The Union Street, Bedford, Turbo Project – View from the Saddle, albeit on foot!

**DfT Cycle Safety Project
Union Street Roundabout, Bedford**

**A View from the Saddle,
- taken on Foot**

Graham Smith and John Meudell

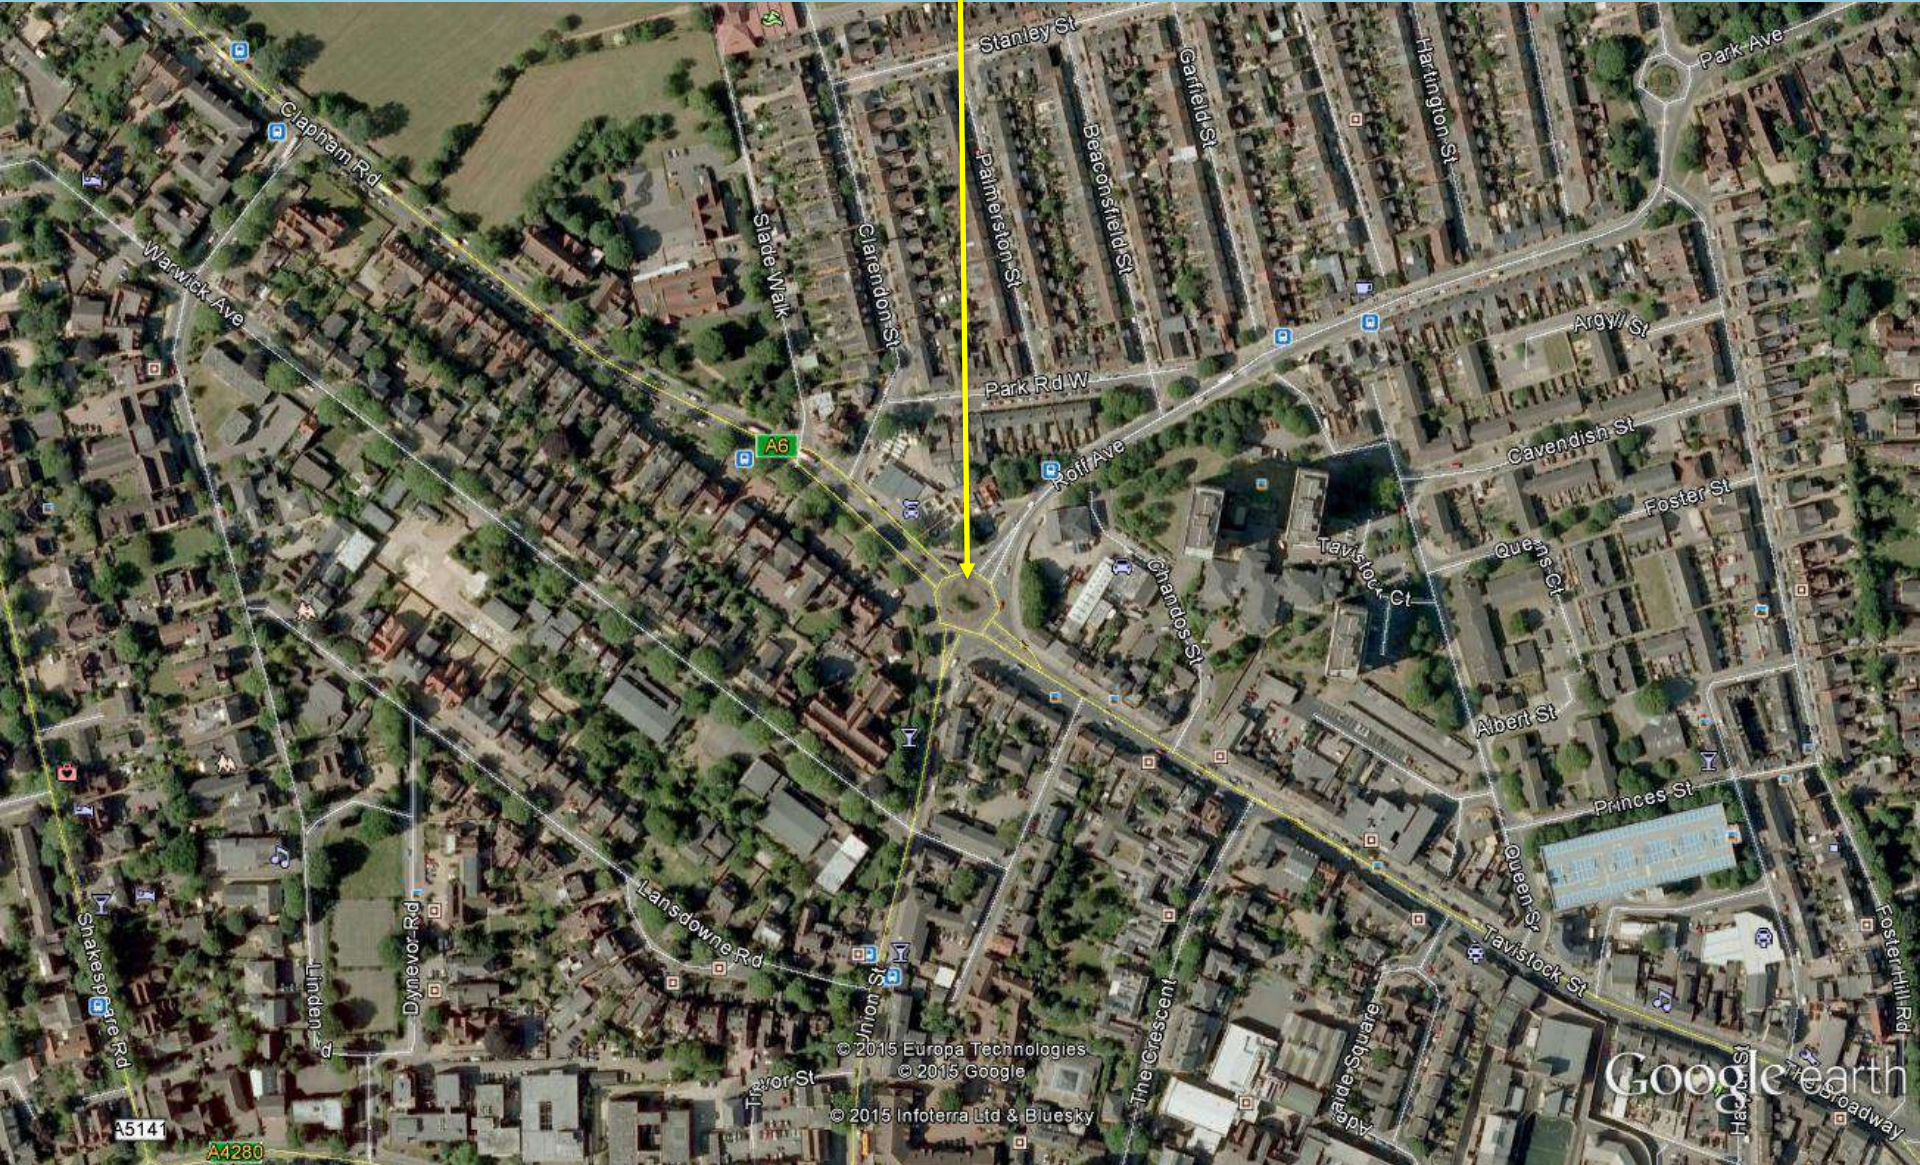
Concept Selection

Union Street, Jct A6 - Bedford

Union Street, Jct A6 – Bedford

Union Street, Jct A6 - Bedford

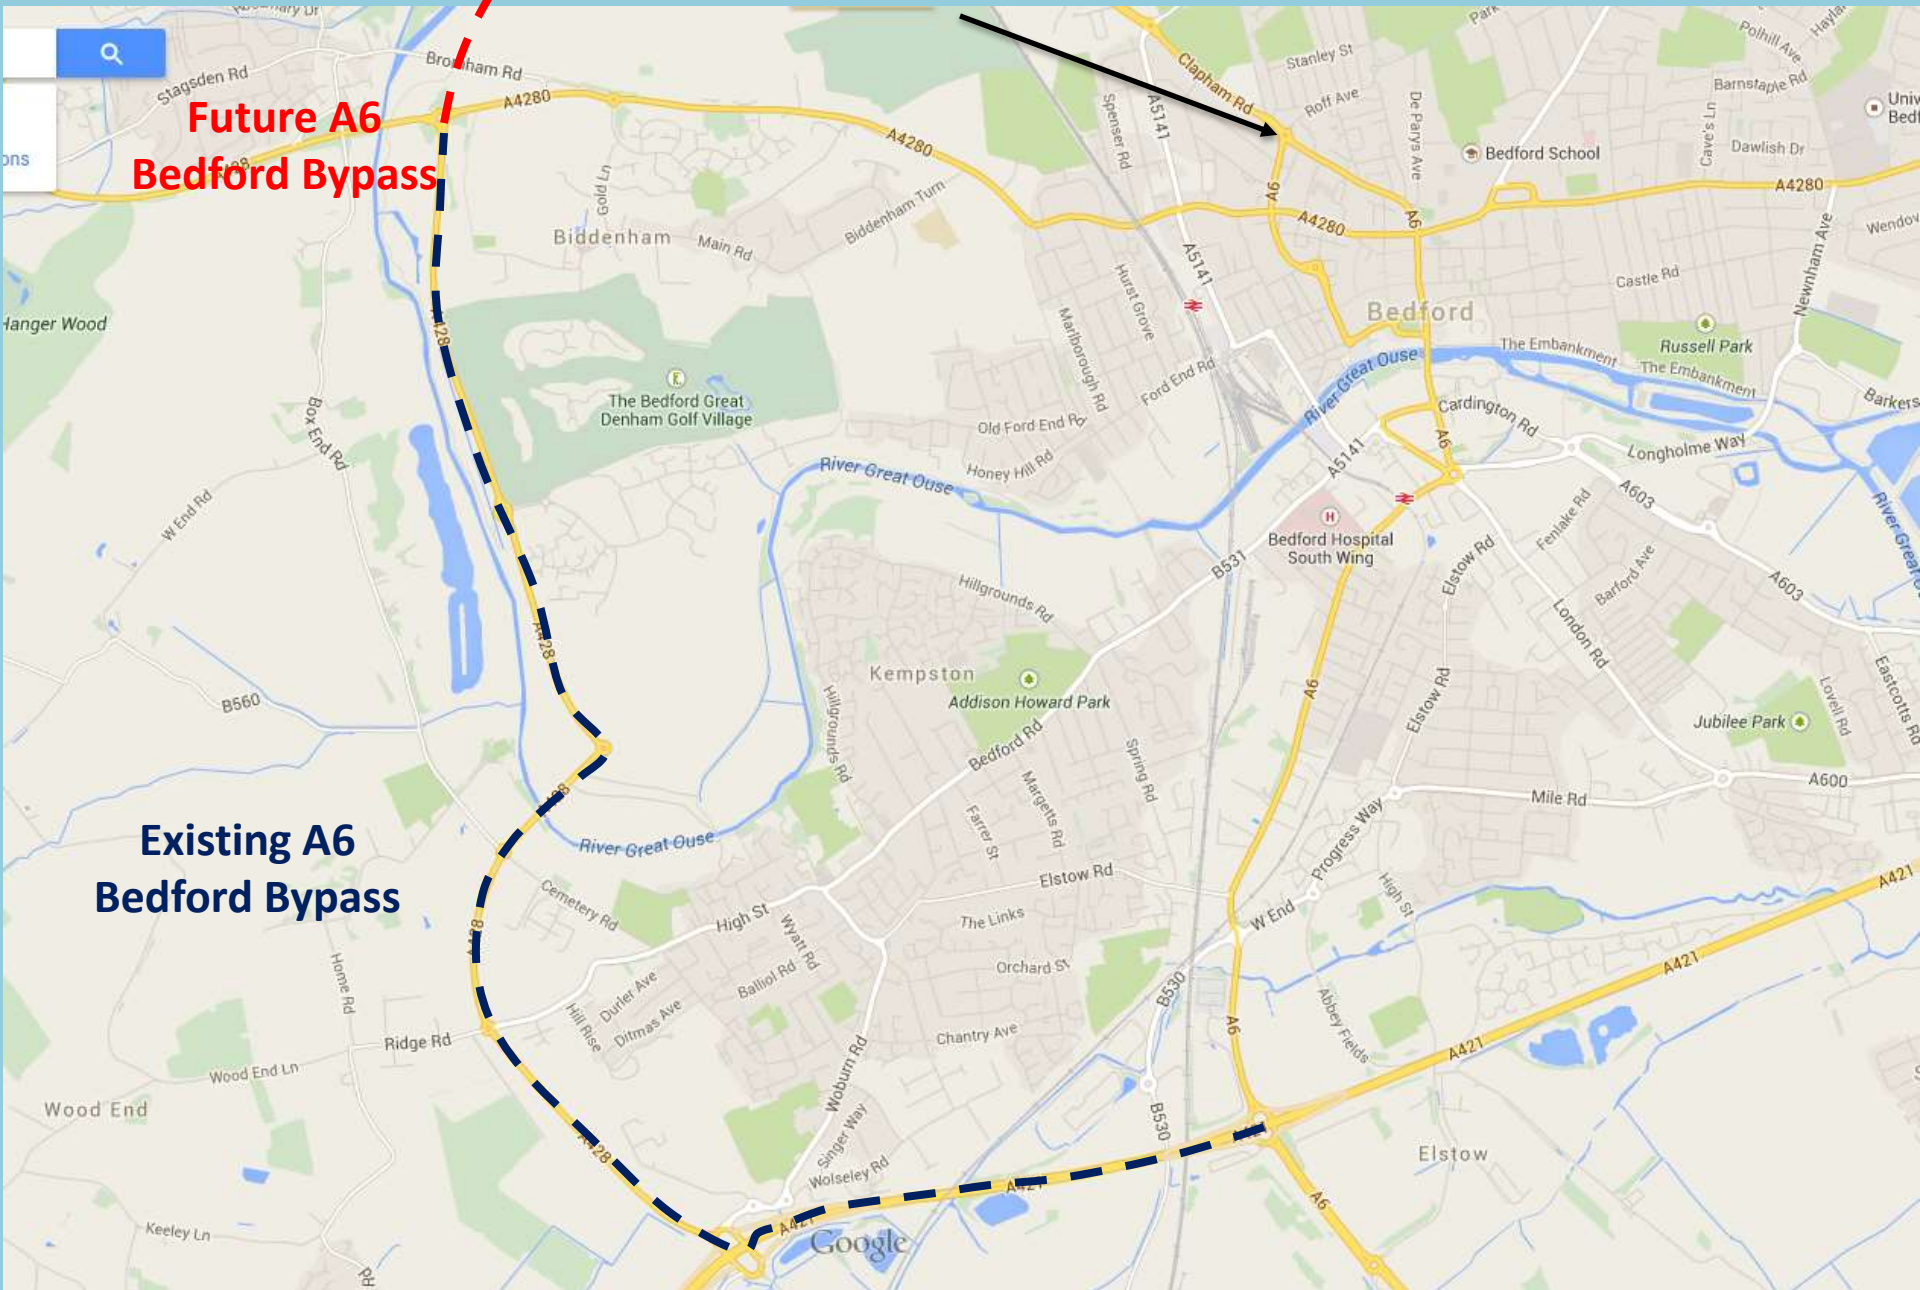
Approx 55m rectangular space
